Access Compliance Report Public Rights-of-Way (Curb Ramps)

Main Street: PERDIDO_ST Cross Street: GUINIDA_LN Location: NE

ADA ID: RPRK210923115018 Ramp Type: Type 1 - Perpendicular Diagonal Initial Pass/Fail: Fail Overall Compliance: No Severity Score: 15

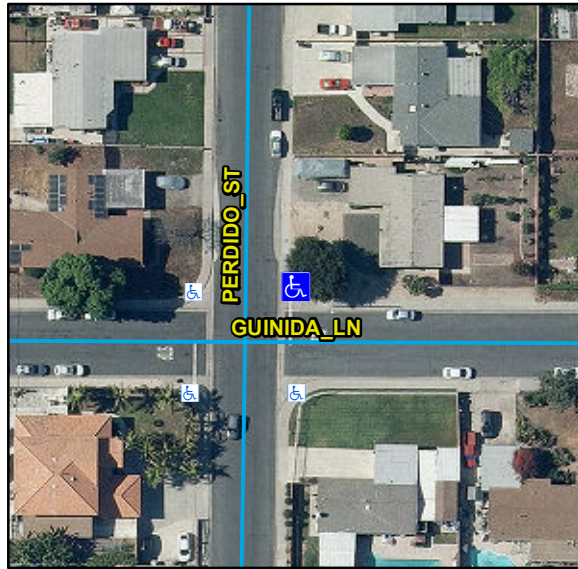
Compliance	Description	Data	Compliance	Description	Data
N/A	Ramp Length (in)	48	N/A	Flare Type LT	
Yes	Ramp Width (in)	48			N/A
No	Ramp Run Slope (%)	11.6	N/A	Flare Slope LT (%)	N/A
Yes	Ramp Cross Slope (%)	1.5	N/A	Flare Traversable LT	N/A
N/A	Landing Present	N/A	N/A	Flare Type RT	
N/A	Landing Length (in)	N/A			N/A
N/A	Landing Width (in)	N/A	N/A	Flare Slope RT (%)	N/A
N/A	Landing Run Slope (%)	N/A	N/A	Flare Traversable RT	N/A
N/A	Landing Cross Slope (%)	N/A	N/A	DWS Provided	N/A
N/A	Landing Movement Obstructed?	N/A	N/A	DWS Contrast	N/A
	Landing Movement Type	N/A	N/A	DWS Length (in)	N/A
N/A	Landing Shared	N/A	N/A	DWS Full Width	N/A
N/A	Clear Space	Yes	N/A	DWS Offset Left (in)	N/A
N/A	Clear Space To Crosswalk (in)	N/A	N/A	DWS Offset Right (in)	N/A
N/A	Marked Crosswalk 1	No	N/A	Marked Crosswalk 2	No
	Crossing 1 Direction	W		Crossing 2 Direction	S
	Marked Crosswalk 1 Width (in)	N/A		Marked Crosswalk 2 Width (in)	N/A

N/A	Ramp Inside Crosswalk 1	N/A	Yes	Ramp Inside Crosswalk 2	N/A
	Crossing 1 Slope (%)	3.9		Crossing 2 Slope (%)	4.7
	Crossing 1 Cross Slope (%)	0.3		Crossing 2 Cross Slope (%)	0.4
N/A	Gutter Ponding	N/A	No	Curb Slope	6.3
No	Gutter Lip Height (in)	0.5		Road Run Slope (%)	4.3
N/A	Gutter Run Slope (%)	N/A		Road Cross Slope (%)	1
N/A	Gutter Cross Slope (%)	N/A			
Yes	Overall Surface Condition: Acceptable		No	Perp Joint Present	No
	Cross Gutter Present?	Yes		Spandrel Present?	Yes
	Replace Cross Gutter?	No		Replace Spandrel?	No

Remove & Replace Curb Ramp With Two New Directional Ramps or Equivalent.

R304.2.2, R204.3, R302.7.2, STD 1115
